MASTER PLAN
MODEL: GARDEN 12 ELEVATION: 3
BEDROOMS: 4
OPTIONS: N/A, LOOK OUT DECK

CITY OF CAMBRIDGE
BUILDING DIVISION

THESE PLANS have been examined for compliance
with the Ontario Building Code Requirements. A
Building Permit is in Order to issue subject to any
changes noted under the condition that the building will
be constructed in accordance with the code

GARDEN 12 (GR)
ELEVATION 1, 2 & 3

BASEMENT PLAN EL-3

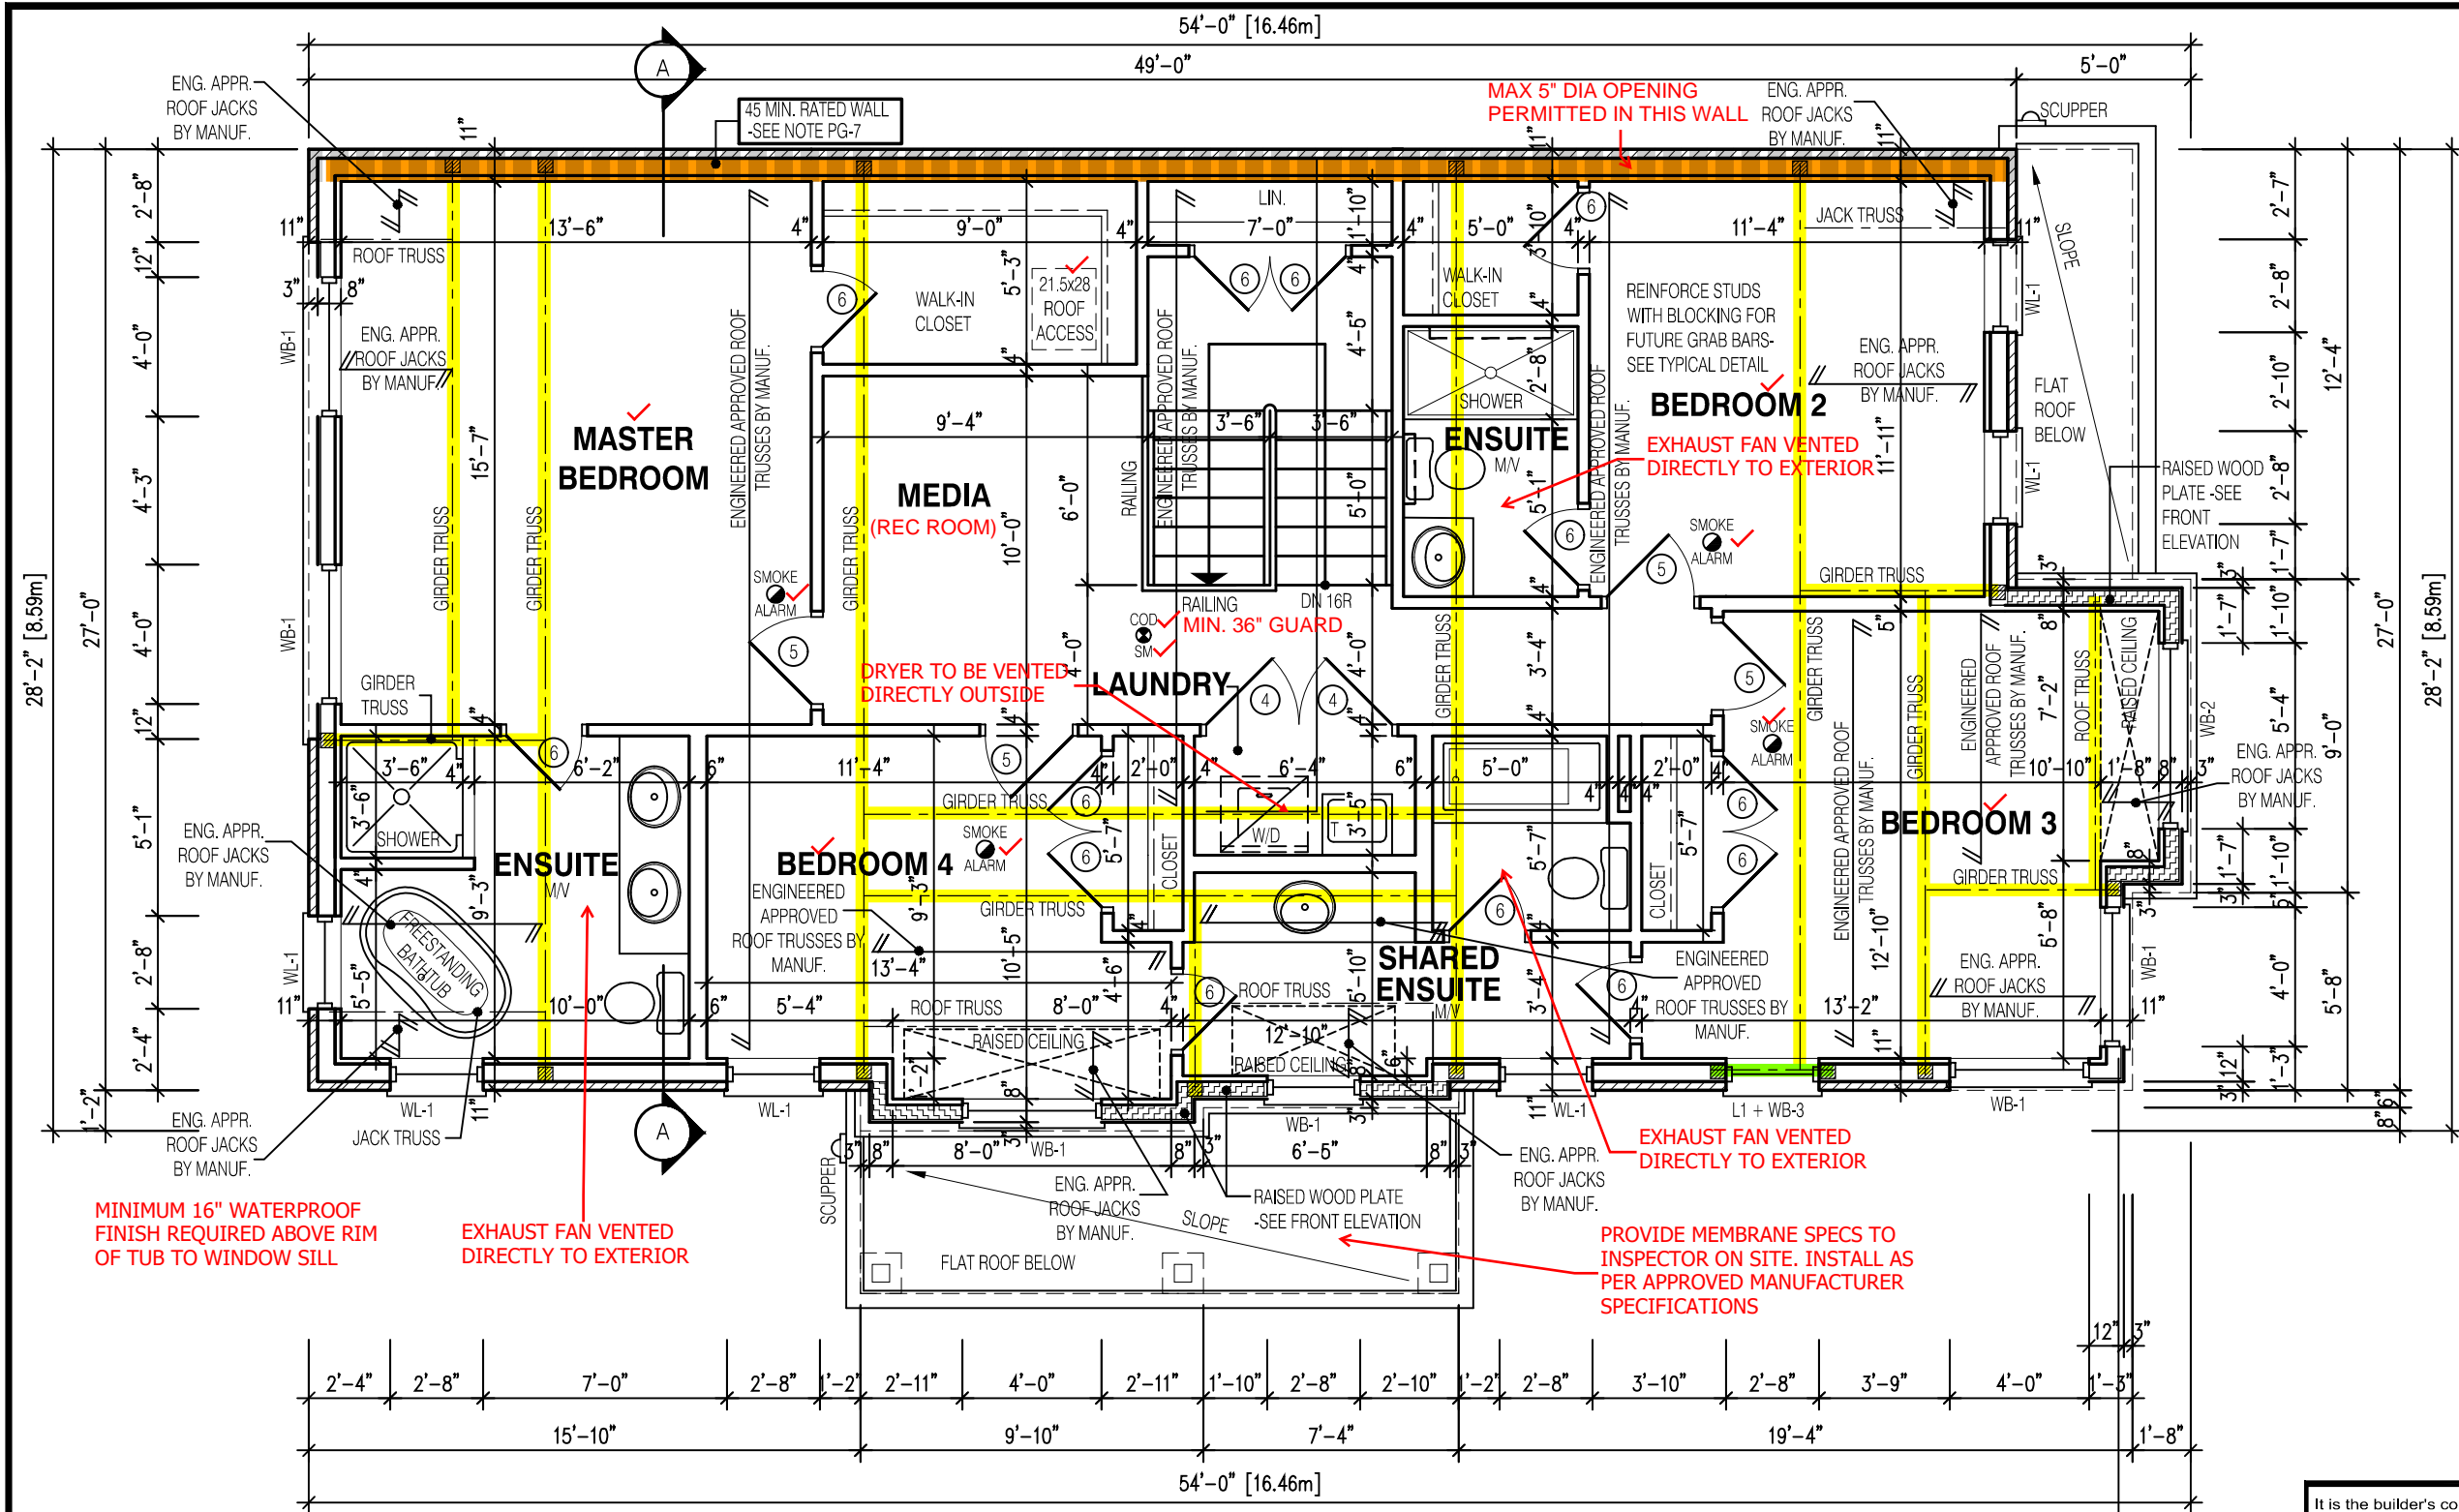
VERIFY WATER METER AND DWHR UNIT LOCATION WITH INSPECTOR

SPRAY FOAM/RIGID INSULATION TO BE PROTECTED AS PER 9.10.17.10.(1)

WATER METER TO BE INSTALLED WITHIN 2m (6'-6") FROM THE POINT THE WATER SERVICE PIPE MEETS THE BUILDING LINE

SEC. FLOOR PLAN EL-3
BARLASSINA CONSTRUCTION
CITY OF CAMBRIDGE

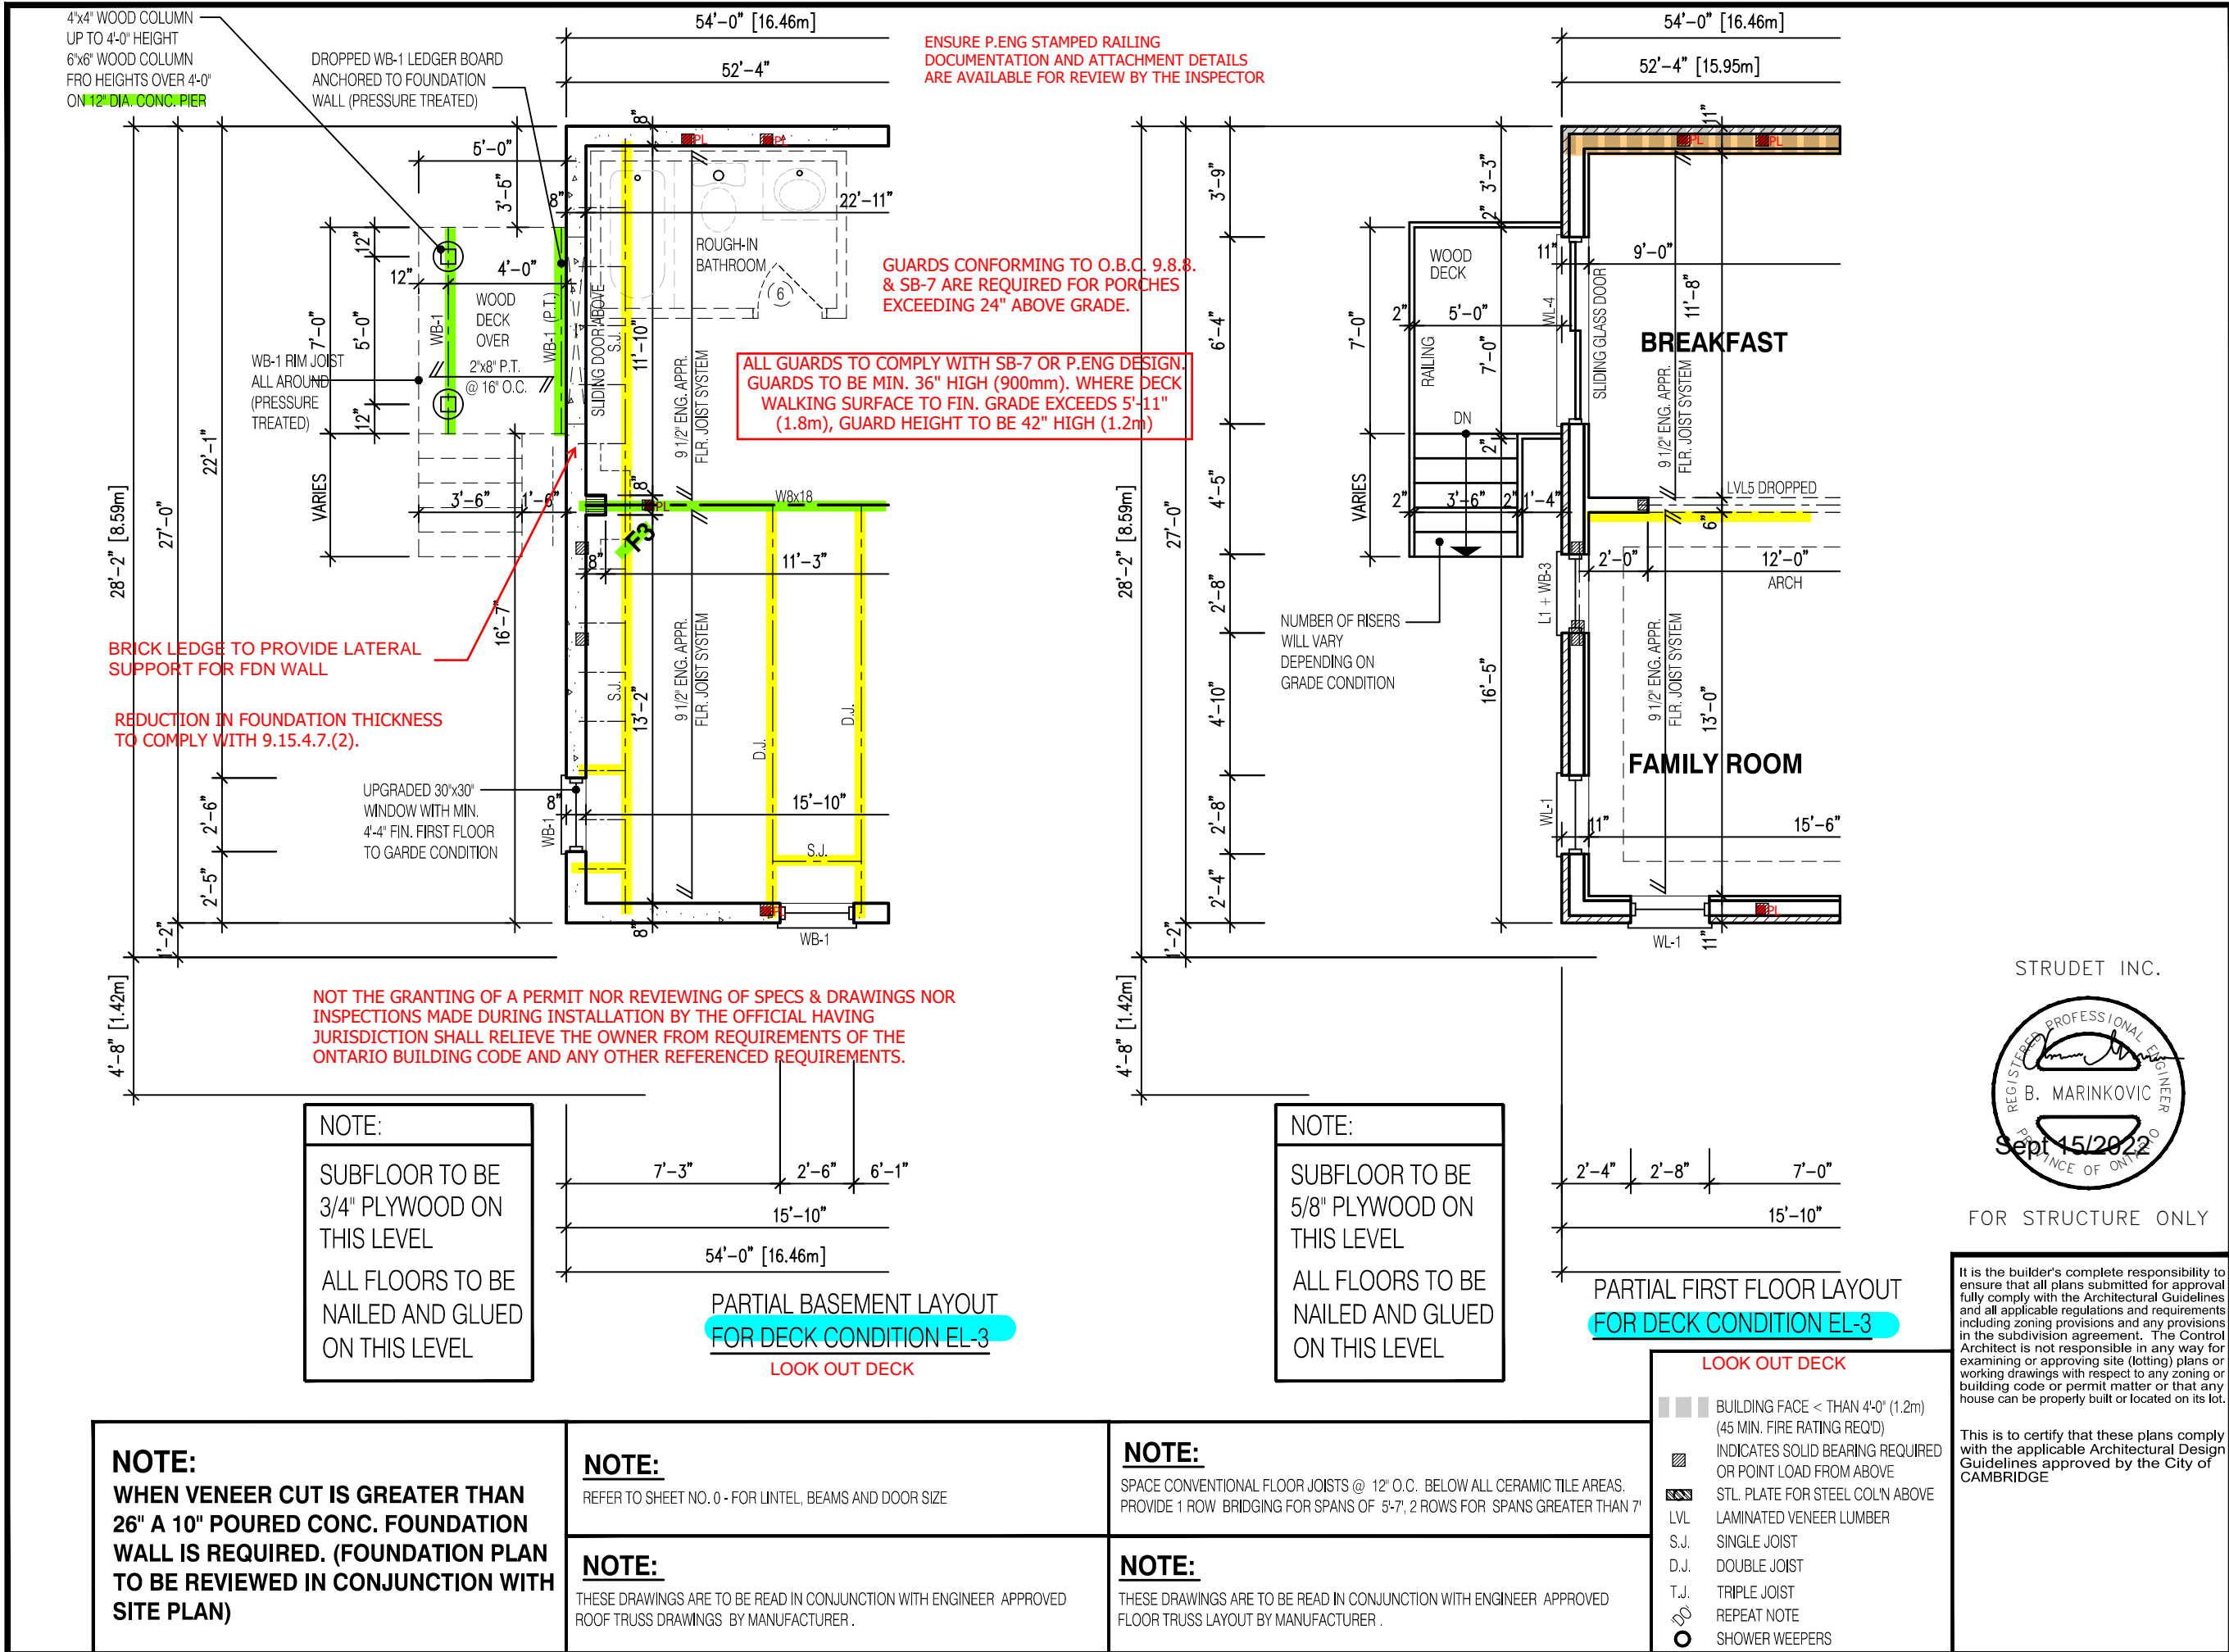
1 WINDOW SHALL PROVIDE AN UNOBSTRUCTED AREA OF 3.8SF w/ NO DIMENSION LESS THAN 15". WINDOW SILL TO BE MAX 39-3/8" ABOVE FINISHED FLOOR.

MAIN BATHROOM TO HAVE STUD BLOCKING FOR FUTURE INSTALLATION OF GRAB BARS ADJACENT TO SHOWER/TUB AND TOILET.

EXPOSED BUILDING FACE REQUIRES A 45MIN F.R.R. w/ 5/8" TYPE "X" DRYWALL & STUDS FILLED w/ INSUL. HAVING A MASS NOT LESS THAN 1.22 KG/M² WHERE LIMITING DISTANCE < 1.2m

GARDEN 12
FRONT ELEVATION 3

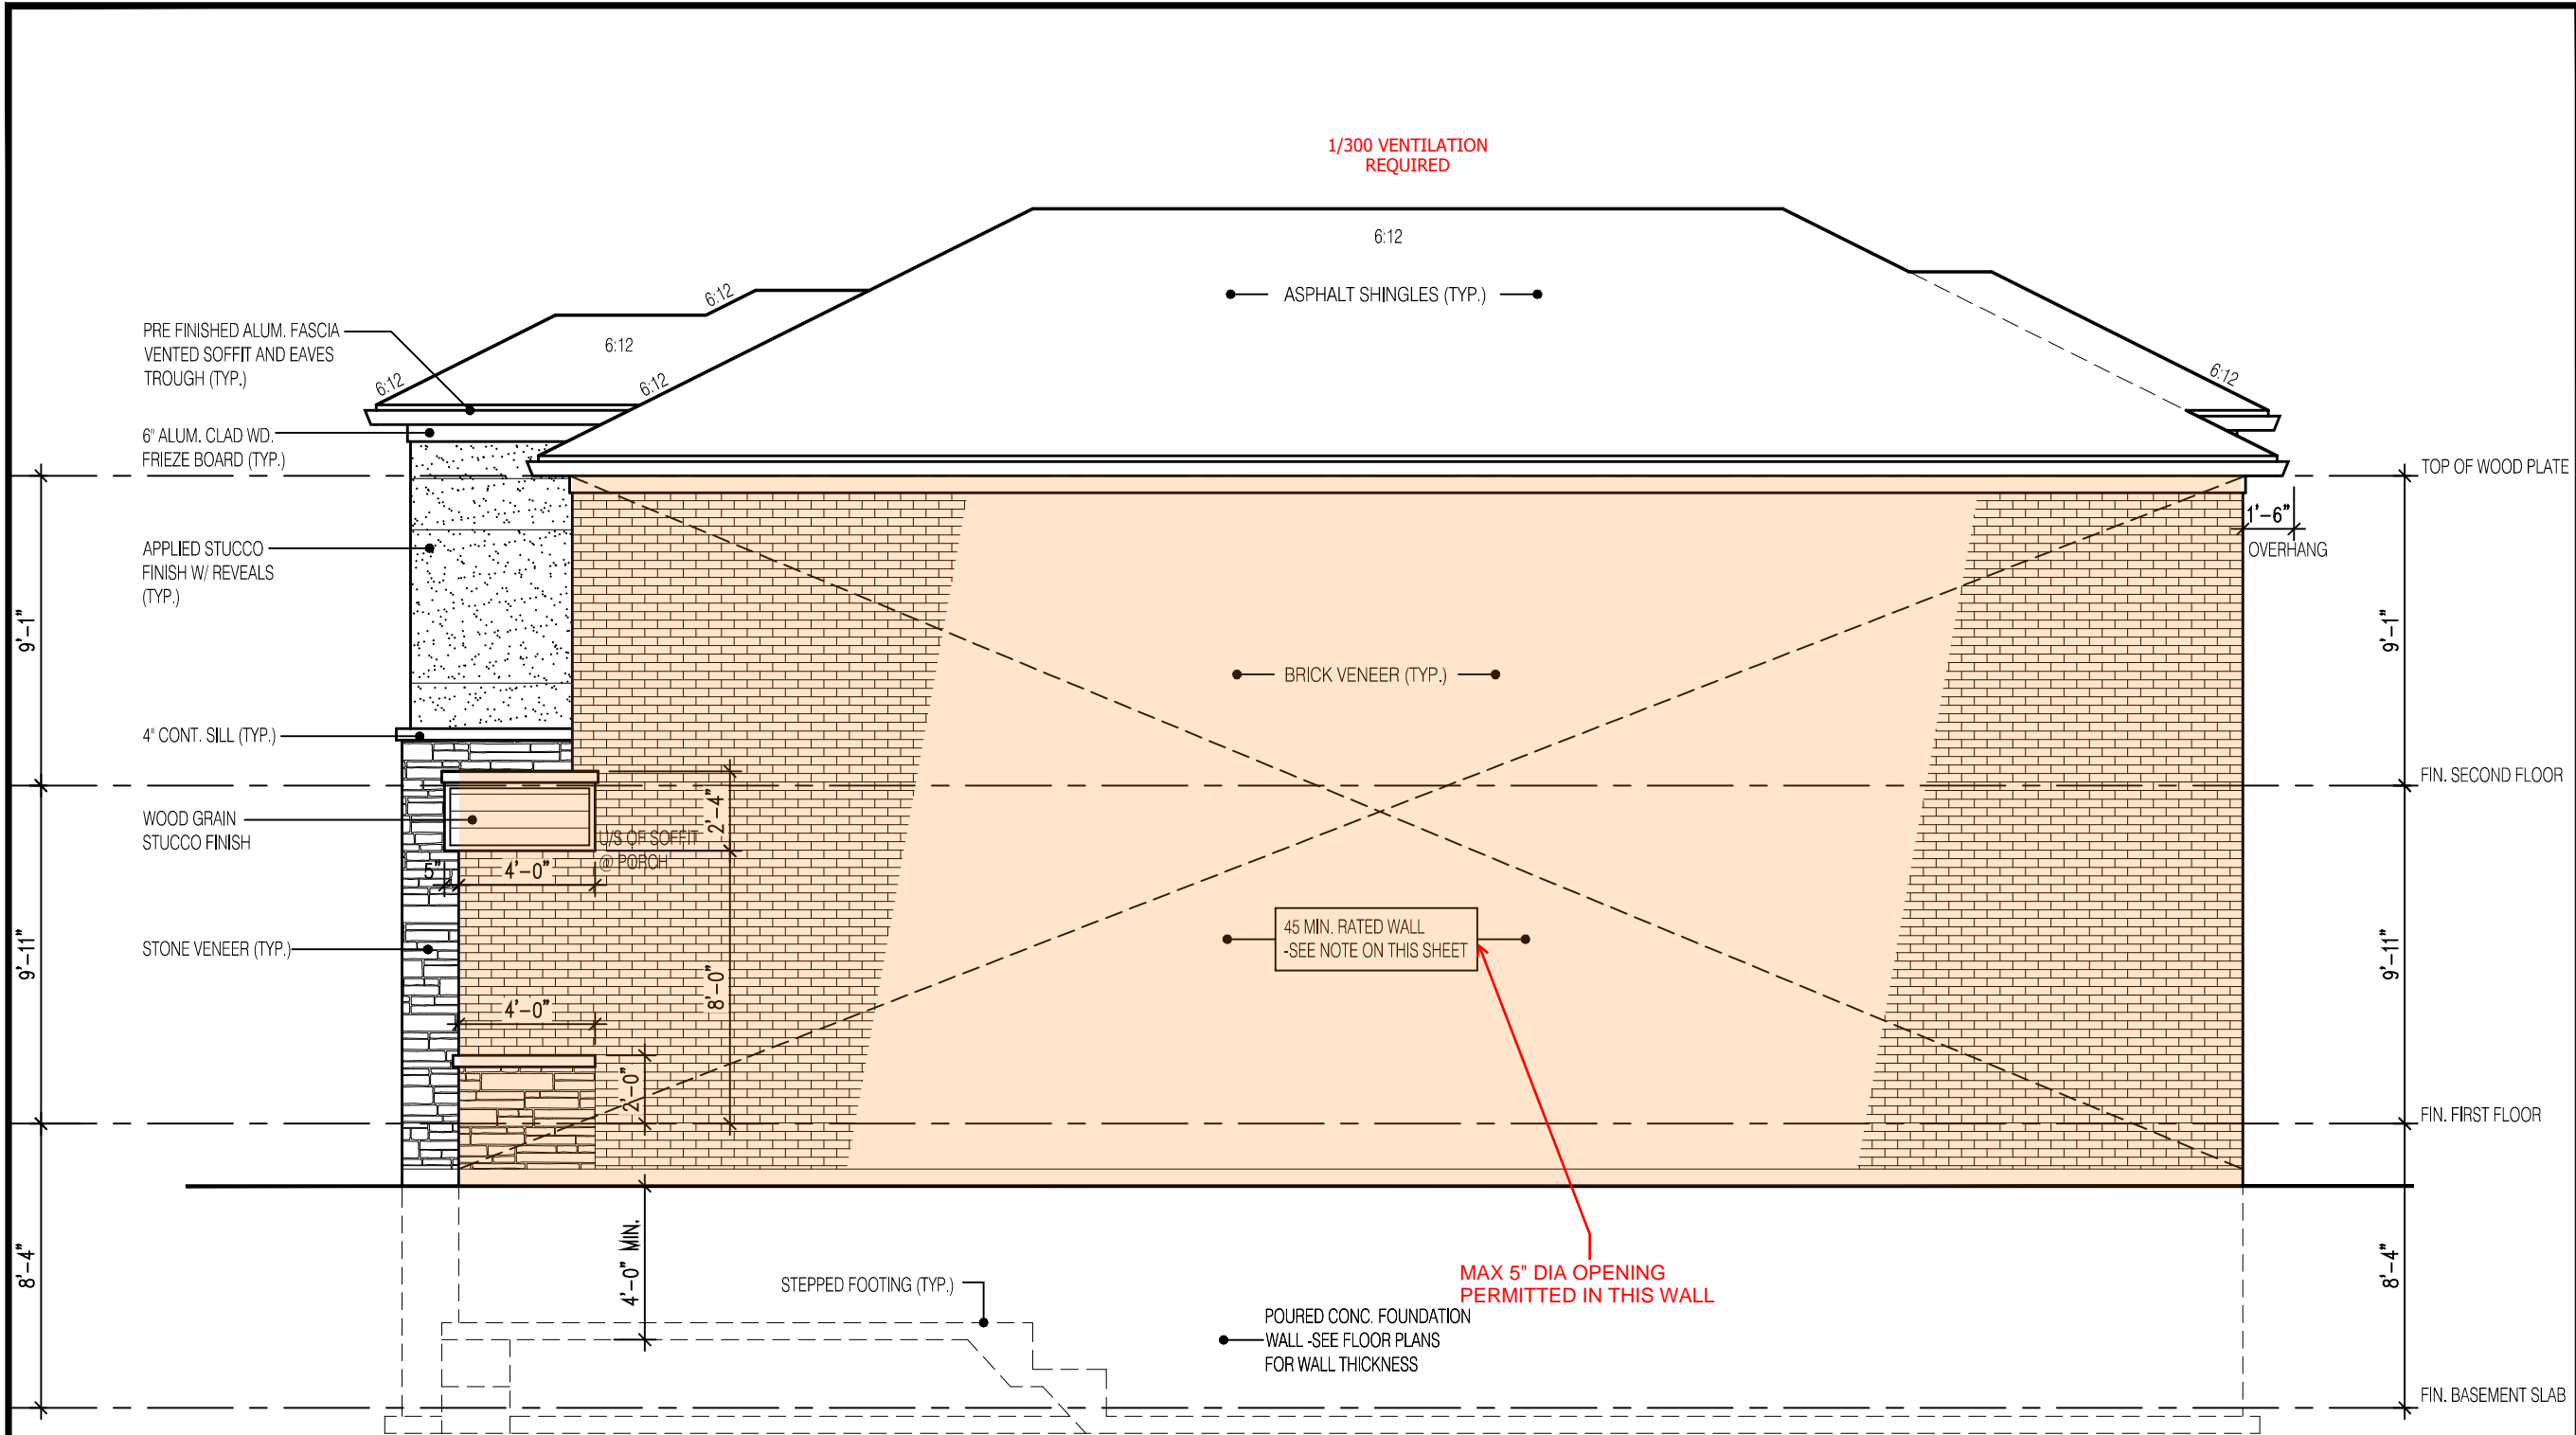
FACES STREET, UPO OK

**A LIGHT IS REQUIRED AT ALL ENTRANCES
TO A SINGLE FAMILY DWELLING**

STEP FOOTINGS. MAX 24"
RISE, MIN 24" RUN

GUARDS CONFORMING TO O.B.C. 9.8.8.
& SB-7 ARE REQUIRED FOR PORCHES
EXCEEDING 24" ABOVE GRADE.

ENSURE P.ENG STAMPED RAILING
DOCUMENTATION AND ATTACHMENT DETAILS
ARE AVAILABLE FOR REVIEW BY THE INSPECTOR

EXTERIOR CONCRETE STAIRS w/ MORE
THAN 2 RISERS TO MEET THE
REQUIREMENTS OF 9.8.9.2.(1)
